Well Name: RED HILLS UNIT	Well Location: T25S / R33E / SEC 33 / NENE /	County or Parish/State:
Well Number: 81H	Type of Well: OIL WELL	Allottee or Tribe Name:
Lease Number: NMNM005792	Unit or CA Name:	Unit or CA Number:
US Well Number: 3002551930	Well Status: Approved Application for Permit to Drill	Operator: CIMAREX ENERGY COMPANY

Sundry ID: 2768274

Type of Submission: Notice of Intent	Type of Action: APD Change
Date Sundry Submitted: 01/04/2024	Time Sundry Submitted: 02:49
Date proposed operation will begin: 03/01/2024

Procedure Description: Cimarex Energy Company respectfully requests the following drilling and directional changes be made to the existing and approved APD for the following well: Red Hills Unit 81H 1. Casing design change - Long String to Liner. 2. New bottom hole location 100 FSL 870 FEL to 100 FSL 1870 FEL. 3. New surface hole location 328 FNL 869 FEL to 388 FNL 1029 FEL. See attached.

WELL LOCATION AND ACREAGE DEDICATION PLAT

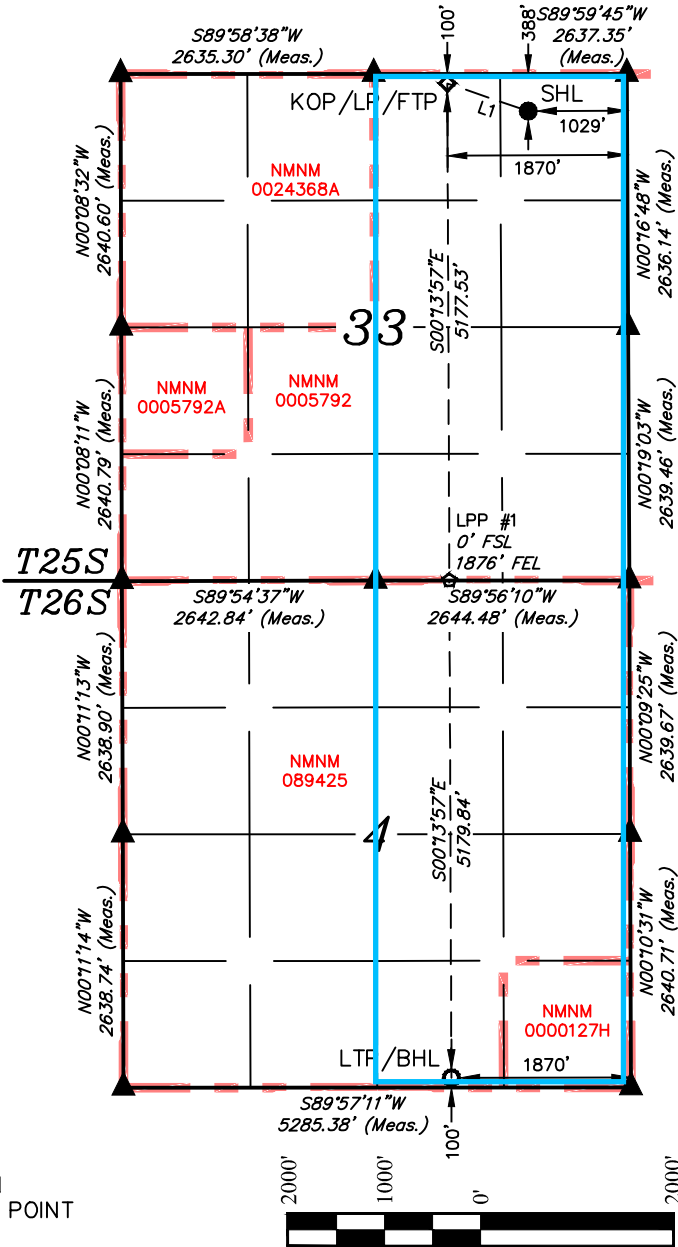
Sundry ID	Well Name	API	S/T/R	SHL Old	SHL New	S/T/R	BHL Old	BHL New
	Red Hills Unit 81H	30-025-51930	33/25S/33E	328 FNL 869 FEL	388 FNL 1029 FEL	4/26S/33E	100 FSL 870 FEL	100 FSL 1870 FEL
		TVD Old	TVD New	MD Old	MD New	Old Formation	New Formation	Producing Zone
		10,000'	10,772'	20,020	20,746	Wolfcamp	Upper 2nd Sand	WC G-09 S253335K;LOWER BONE SPRING

UL or lot no.	Section	Township	Range	Lot Idn	Feet from the	North/South line	Feet from the	East/West line	County
A	33	25S	33E		388	NORTH	1029	EAST	LEA

UL or lot no.	Section	Township	Range	Lot Idn	Feet from the	North/South line	Feet from the	East/West line	County
O	4	26S	33E		100	SOUTH	1870	EAST	LEA
¹² Dedicated Acres 360	¹³ Joint or Infill	¹⁴ Consolidation Code	¹⁵ Order No.
